19 September 2022

Subject: Addendum to the bushfire assessment for Carseldine Village

Land and Environment Consultants Pty Ltd (**LEC**) prepared a bushfire assessment and management plan and bushfire attack level (**BAL**) contour plan for Carseldine Village at 532 Beams Road, Carseldine (**the site**), properly described as lot 322/SP172124.

Client Economic Development Queensland Carlseldine Village		Project Carlseldine Village
Design Drawn Scale Cad File	Land Environment Consultants 24.06.2022 MP 1:2000 47 Carlseldine UV10.dwg Rev 4.0	Title Revised Radiant Heat Flux Contours FIGURE 1

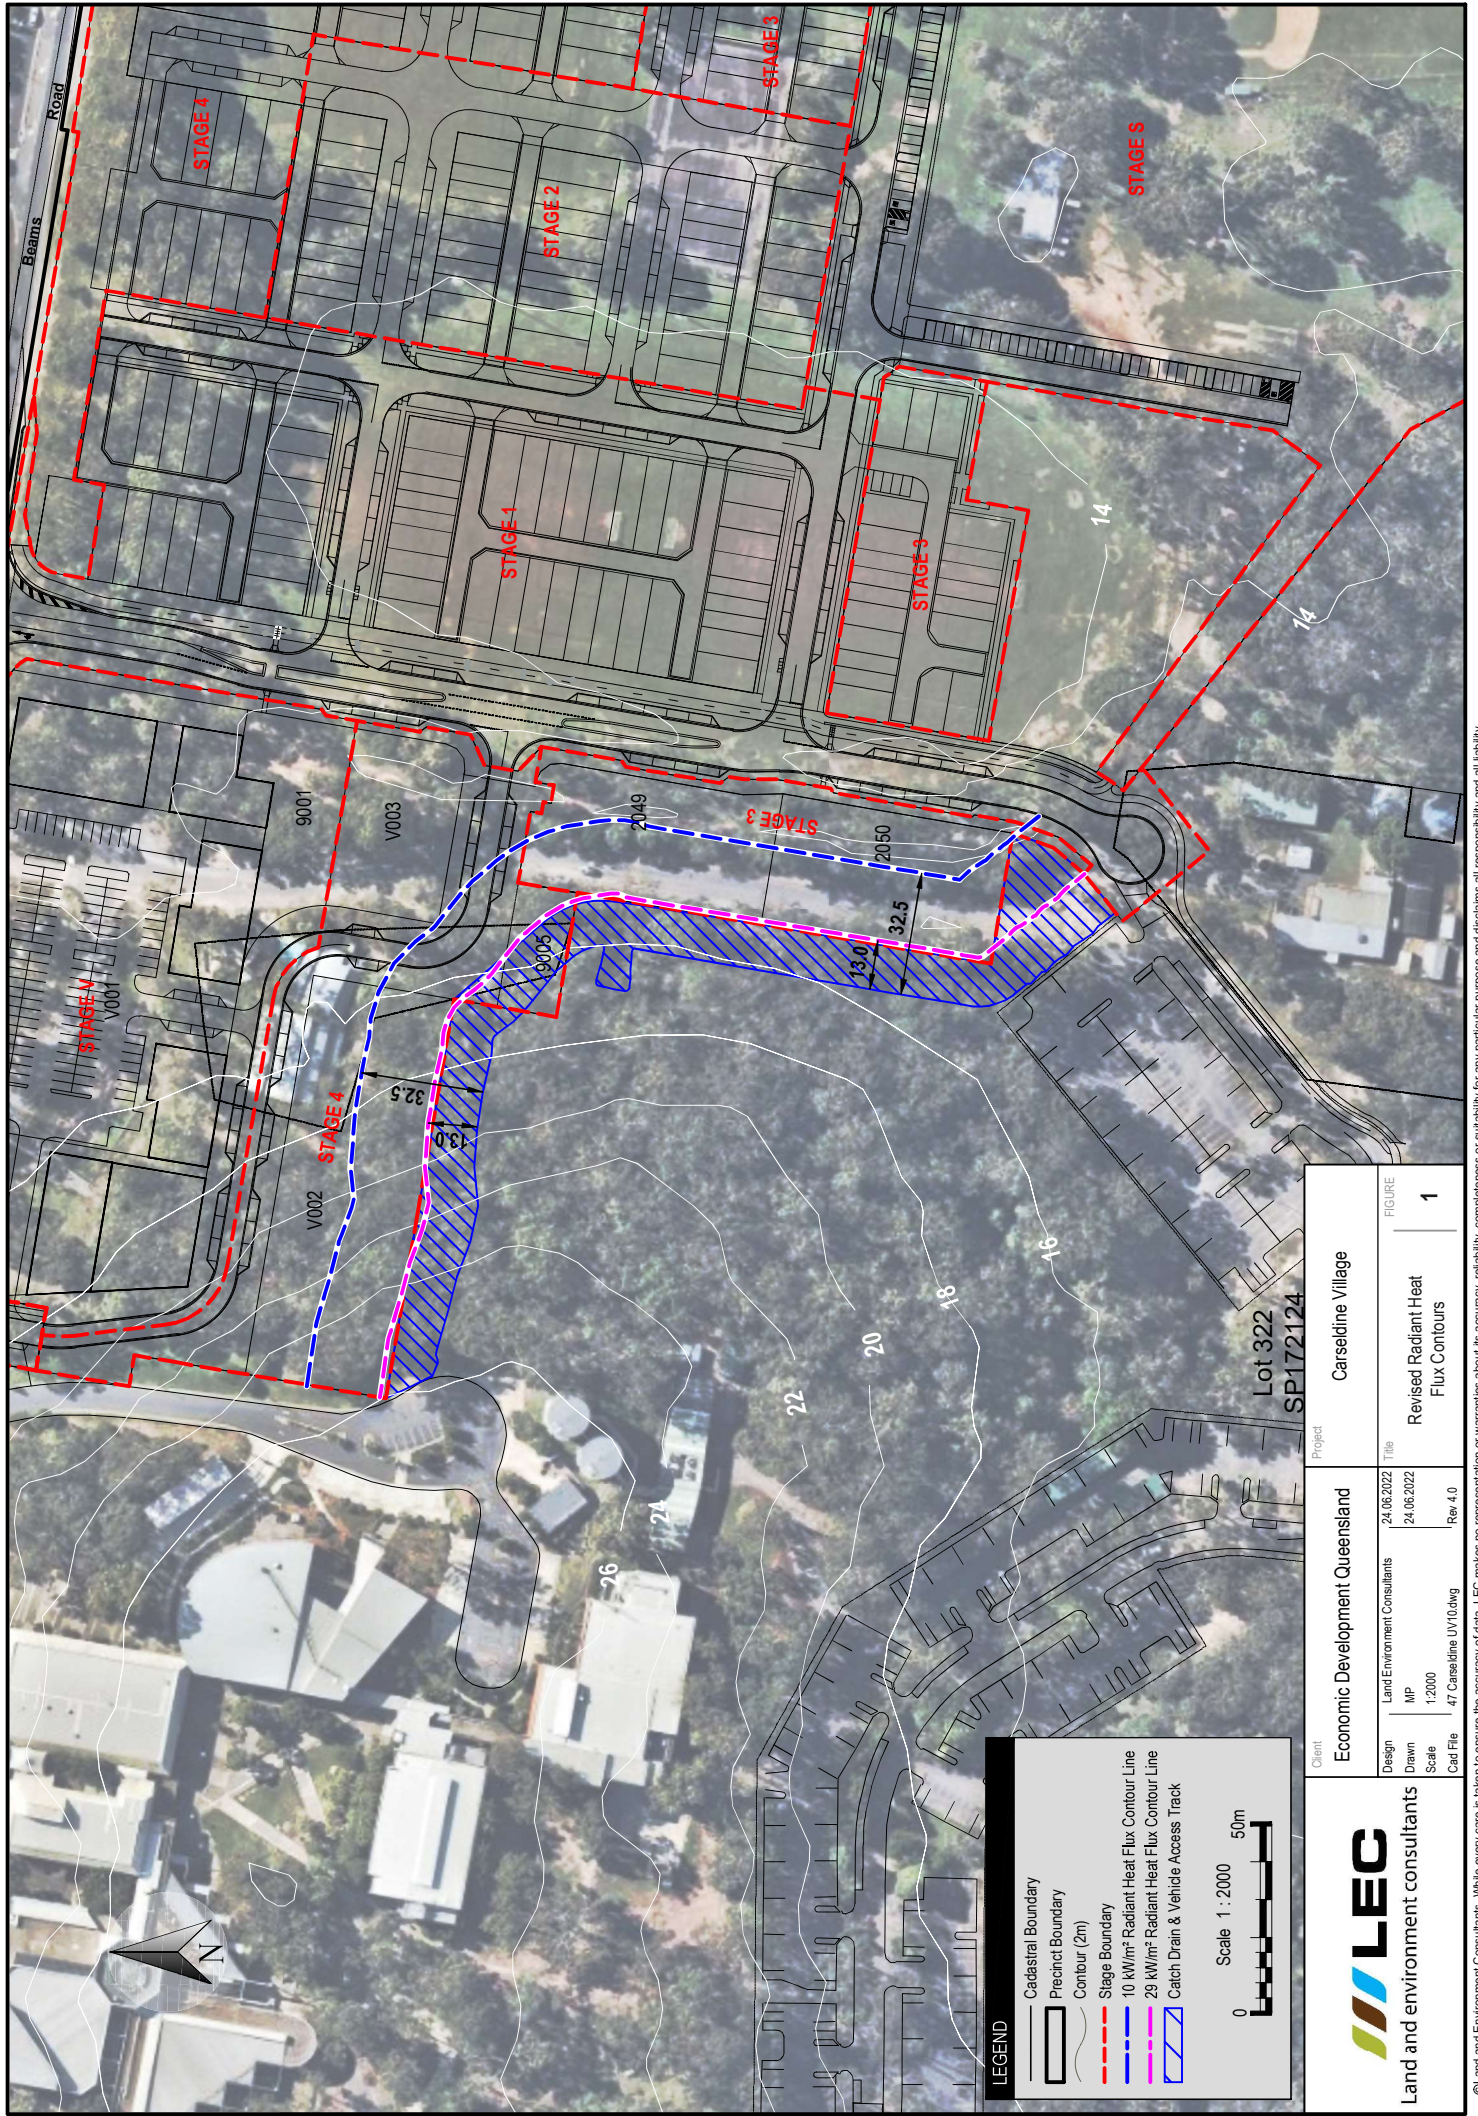
The stormwater drainage swale will be designed and maintained to provide a low fuel hazard area and separation for new buildings within lots 2049, 2050 and V002 from the adjacent bushfire hazard area. On this basis, the revised location of the 10 kW/m^2 and 29 kW/m^2 radiant heat flux contours in relation to lots 2049, 2050 and V002 is shown in Figure 1.

Figure 1 demonstrates that future site planning within lots 2049, 2050 and V002 is no longer constrained by the 29 kW/m^2 radiant heat flux contour (with the exception of a minor intrusion into the rear boundary of lot V002).

Client		Economic Development Queensland		Project		Carseldine Village	
Design	MP	24.06.2022	Title	24.06.2022	FIGURE	2	
Drawn	Scale	1:2500			Revised BAL contours		
Cad File		47 Carseldine UV10.dwg	Rev	4.0

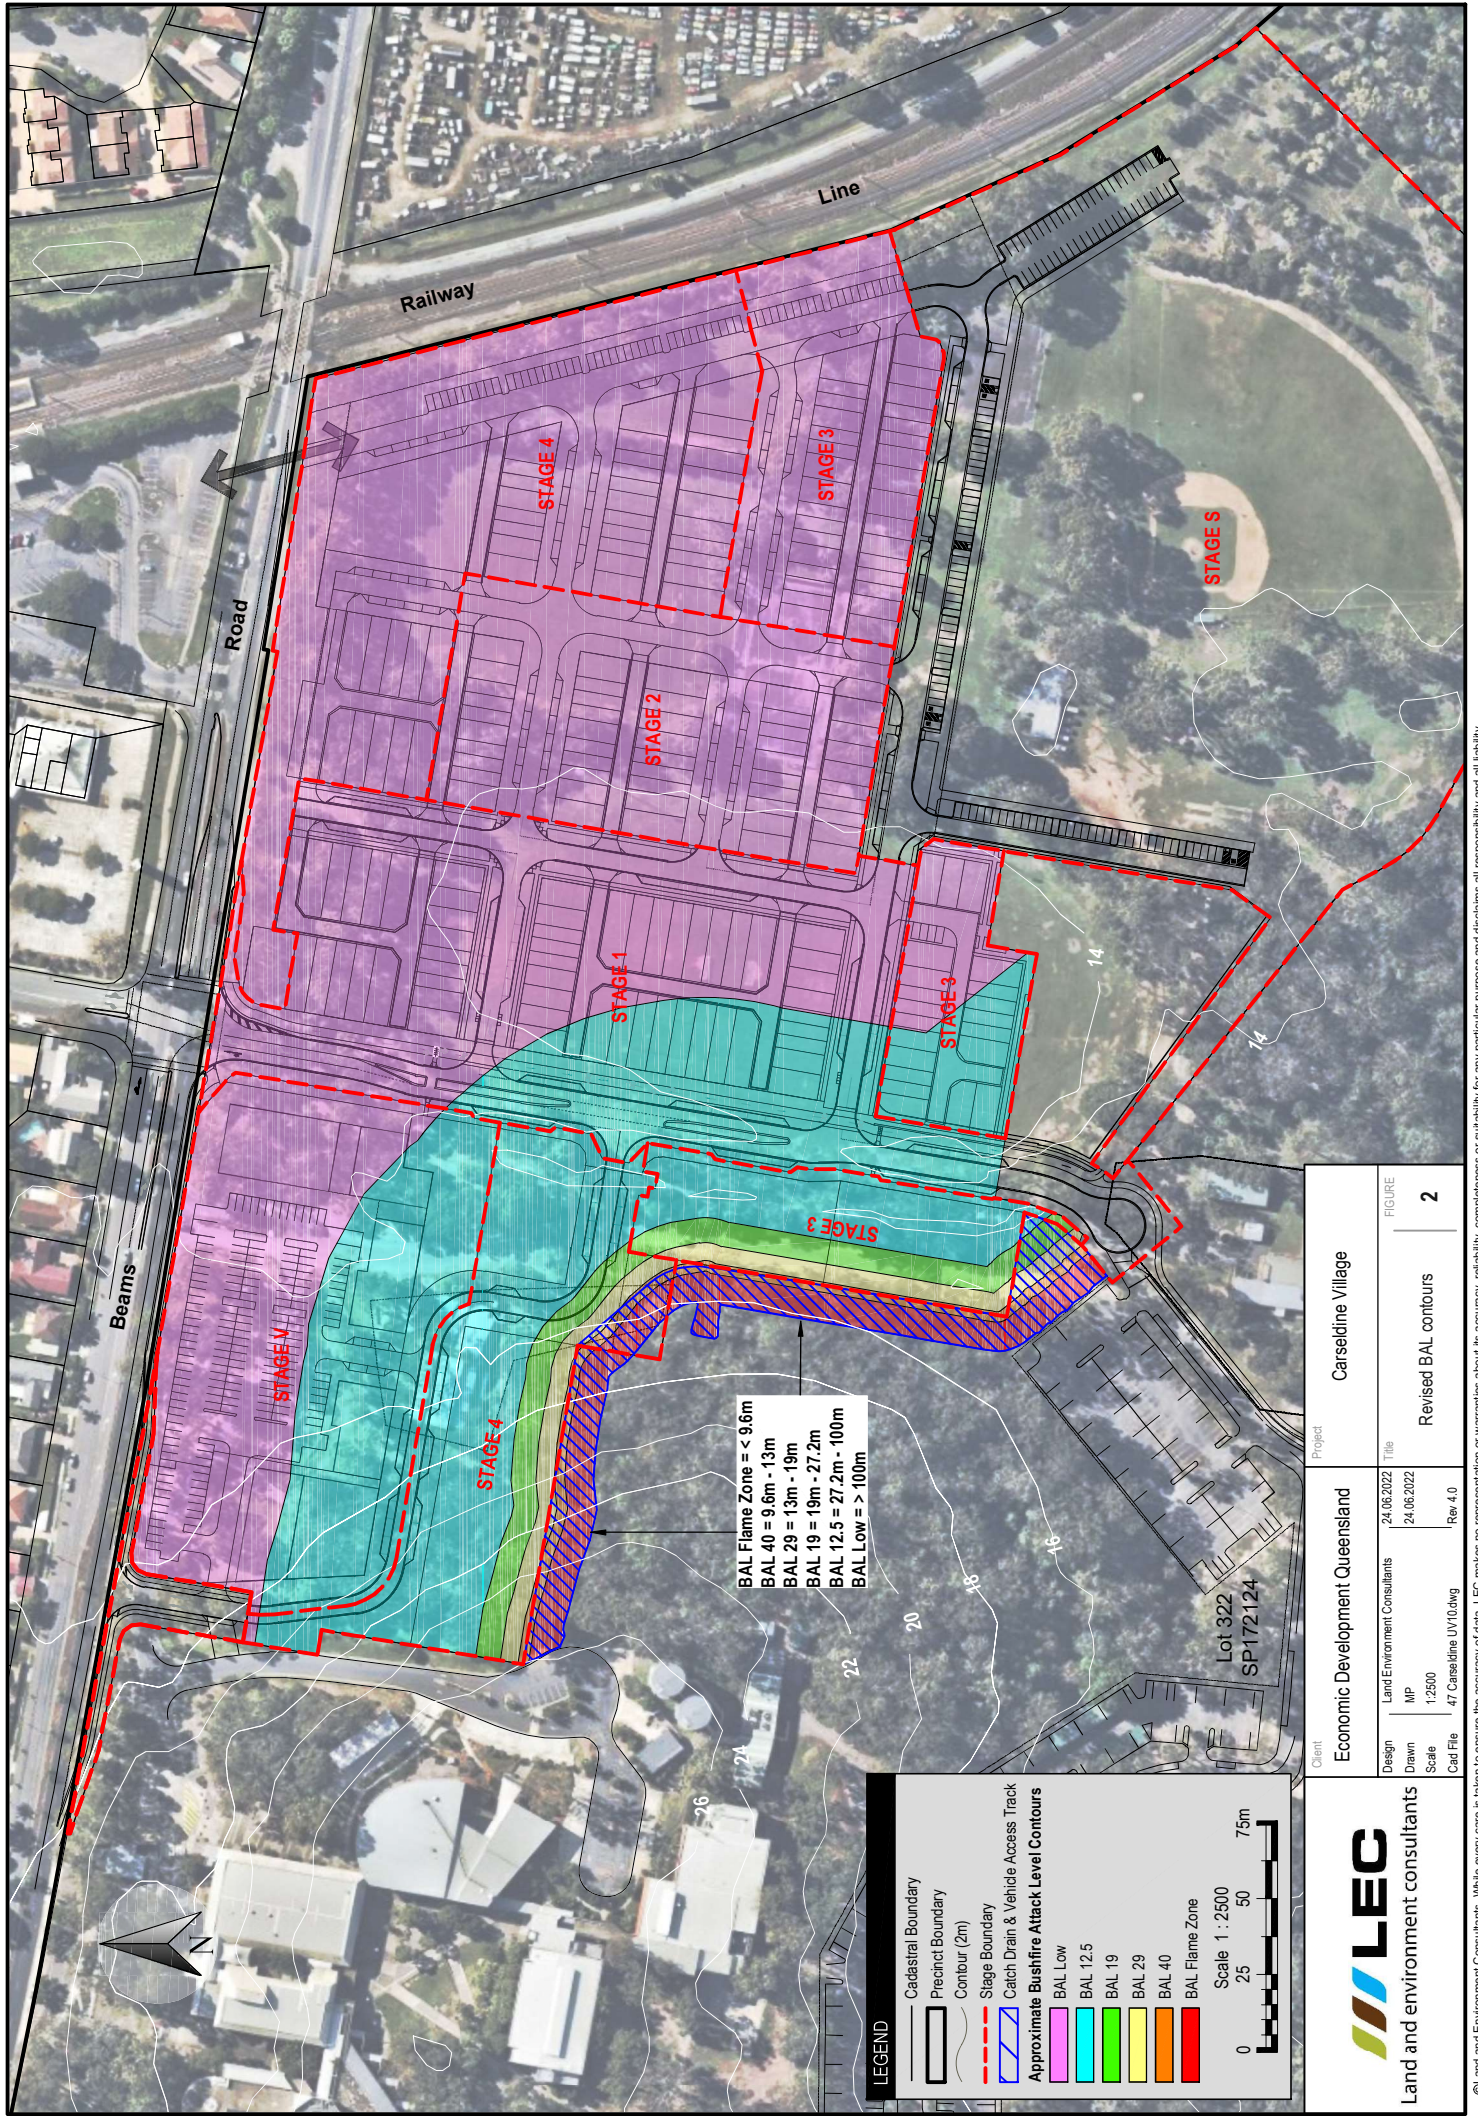
The revised alignment of BAL contours over stages 1-4 and V of Carseldine Village are shown in Figure 2.

TEMPORARY TURNAROUND DETAIL
SCALE 1:100

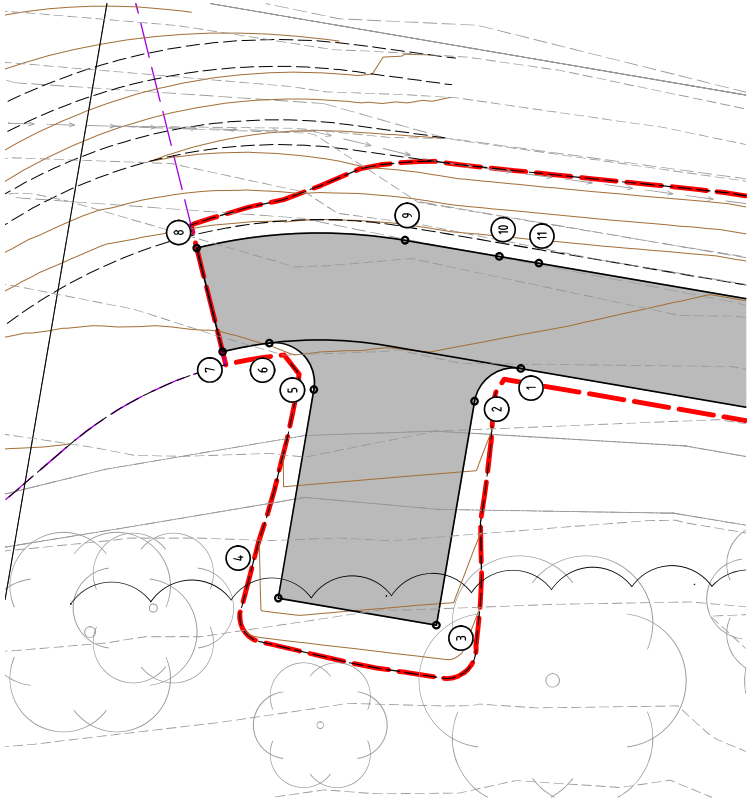
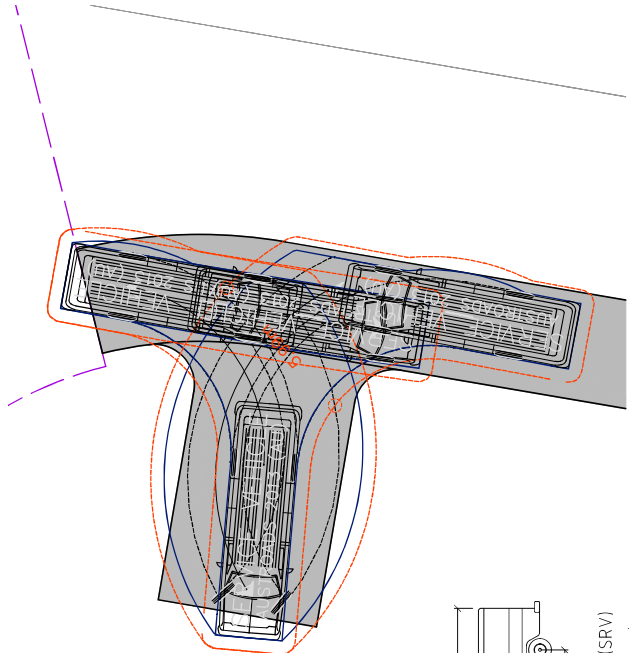
Phase 1 of the restricted vehicle access track is aligned with the rear boundaries of lots 2049 and 2050. It will be 130 m long and will be a dead end track for a temporary period of 9-12 months until Phase 2 works are completed. As a result, the Phase 1 restricted vehicle access track includes a reversing bay/turnaround area which is 6 m wide by 8 m deep.
